# Access Compliance Report

## Public Rights-of-Way

Intersection ID: 28313	Main Street: ALBURY_WALK_LN	Cross Street: HANWORTH_TRACE_DR	Location: NE
ADA ID: 886FC98BB420	Ramp Type: Perp	Initial Pass/Fail: Fail	Overall Compliance: No
Codes/Mitigation Info/Possible Solution		Field Measurements/Component Compliance	
Severity Score: 13.75

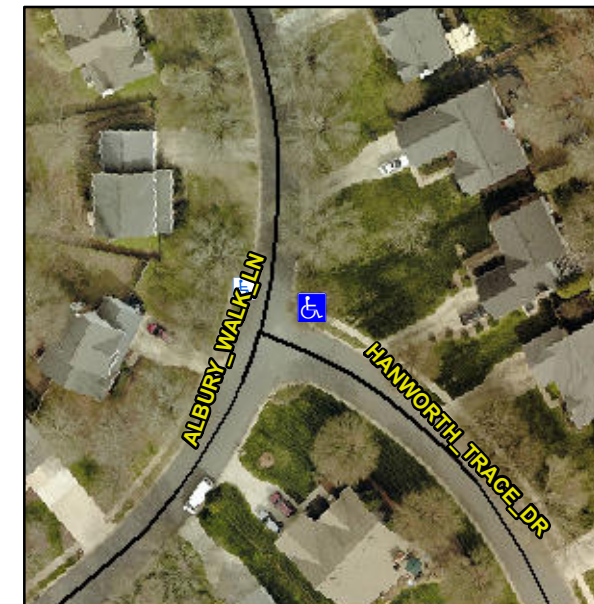
**Not Found, R304.2.2, R304.5.3**

Compliance	Description	Data	Compliance	Description	Data
N/A	Ramp Length (in)	54.0	No	Ramp Slope (%)	9.8
Yes	Ramp Width (in)	96.0	No	Ramp XSlope (%)	3.6
N/A	Flare Type LT	N/A	N/A	Flare Type RT	N/A
N/A	Flare Slope LT (%)	N/A	N/A	Flare Slope RT (%)	N/A
N/A	Flare Traversable LT?	N/A	N/A	Flare Traversable RT?	N/A
N/A	Landing Length (in)	N/A	N/A	DWS Provided?	N/A
N/A	Landing Width (in)	N/A	N/A	DWS Contrast?	N/A
N/A	Landing Slope (%)	N/A	N/A	DWS Length (in)	N/A
N/A	Landing X Slope (%)	N/A	N/A	DWS Full Width?	N/A
N/A	Landing Curb? (Y/N)	N/A	N/A	DWS Offset (in)	N/A
N/A	Shared Landing?	N/A			
N/A	Gutter Ponding?	N/A	N/A	Gutter Slope (%)	N/A
N/A	Gutter Lip Ht (in)	N/A	N/A	Gutter X Slope (%)	N/A
N/A	Painted X Walk1?	No	N/A	Painted X Walk2?	N/A
	X Walk 1 Direction	To NW		X Walk 2 Direction	N/A
N/A	X Walk 1 Width (in)	N/A	N/A	X Walk 2 Width (in)	N/A
	X Walk 1 Slope (%)	5.5		X Walk 2 Slope (%)	N/A
	X Walk 1 X Slope (%)	0.8		X Walk 2 X Slope (%)	N/A

**Remove & Replace Entire Ramp.**
